Post-Construction Audit

Tapestry

750 West 12th Avenue
Vancouver, British Columbia

Report No. 5075201.00

Photo 20.JPG

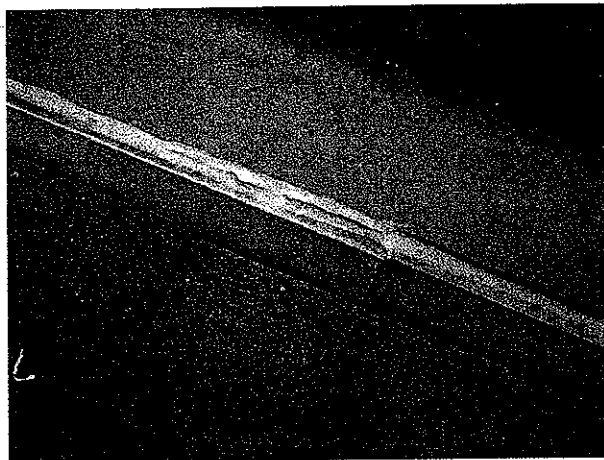
20	D	North Building – The gum edge flashing detail along the roof deck perimeter is starting to fail. The sealant is cracking and debonding at various locations.	Remove and replace gum edge sealant as required.
21	M	Vent Shafts – Debris is collecting in the bottom of the vent shafts and ponding was observed in the bottom.	Review vent shafts and clear debris as required. Ensure drains are clear and free draining.
